**METROPOLITAN GOVERNMENT OF NASHVILLE AND DAVIDSON COUNTY**

**STAFF RECOMMENDATION**  
**1813 Holly Street**  
**October 15, 2014**

**Application:** New construction-addition

**Description of Project:** The application is for a rear one-and-a-half story addition to a contributing Craftsman-style home. A similar plan was approved in July of 2014. Previously, the addition would match the height of the house; in the revised plans, the addition will be taller than the historic house.

Figure 2: Right side façade.

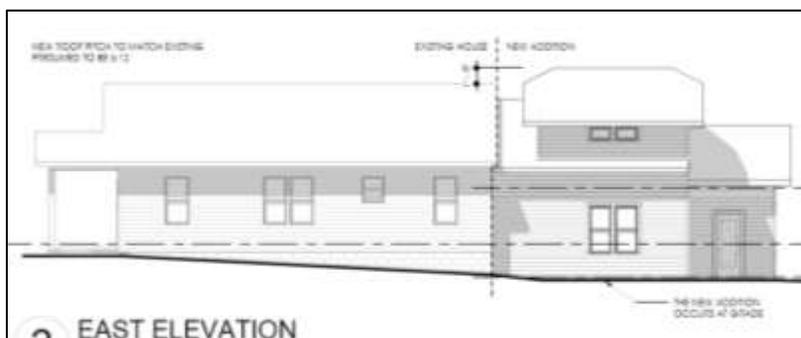
The roof of the addition will tie into the house twenty inches (20”) below the existing ridge, and then step up twenty inches (20”) above the ridge at the rear.

The new roof will align with the slope of the left side of the existing roof, and because the ridge is taller, the right slope of the roof will be approximately three feet (3’) higher than the existing roof. Staff finds that with this configuration, the perceived scale of the addition will not be sufficiently subordinate to the historic house. In order to reduce the visibility of the vertical wall of this portion of the addition, staff recommends that the

right side wall of the upperstory should sit in an additional two feet (2') from the right side of the house.

Figure 3: Front façade. Staff recommends pushing the right wall of the addition, (see arrow) in an additional two feet (2') to reduce the massing.

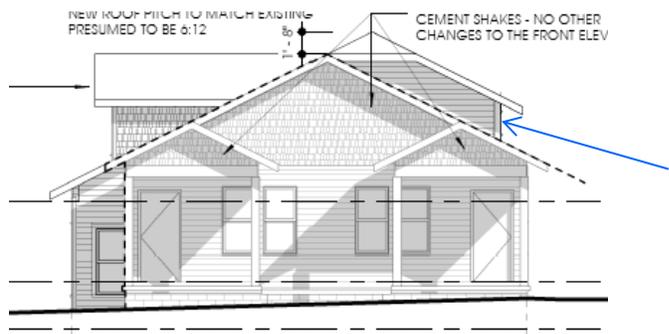
Although the width and location of the addition are appropriate, the height of the addition as viewed from the right side will not be sufficiently subordinate to the historic house. The ability to hide additions for front-gable homes is problematic and further exacerbated by the fact that the existing house is short and narrow.

Staff finds that the project can meet section II.B.2 and 10 of the design guidelines if the right side wall of the upperstory is inset an additional two feet (2').

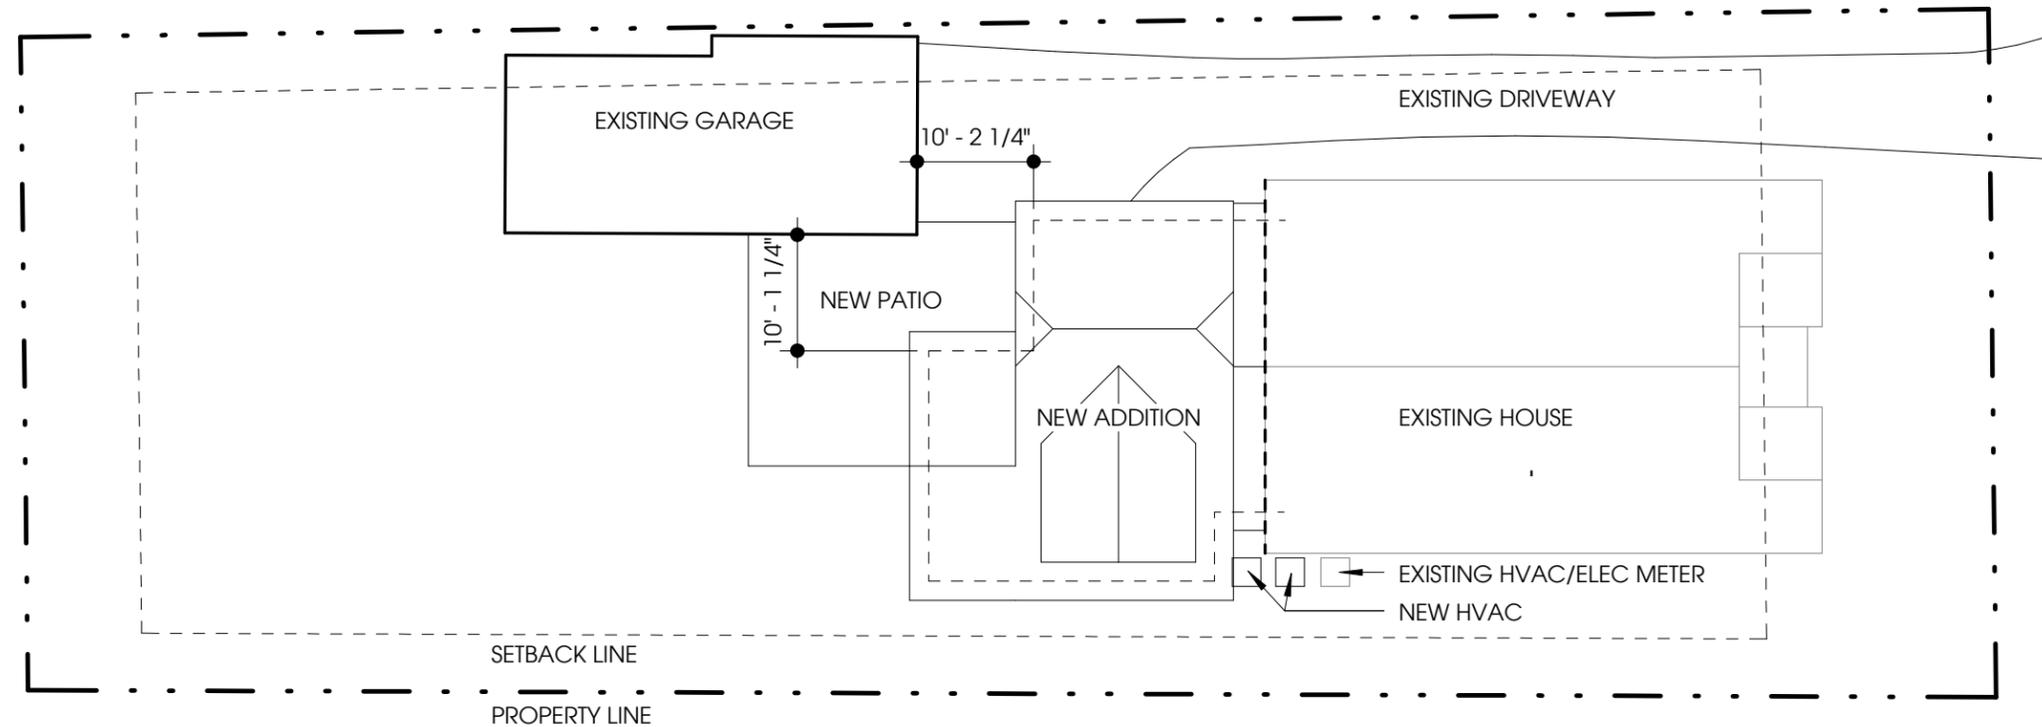
Right-front oblique of 1813 Holly Street. The proposed addition would be very visible from this perspective.
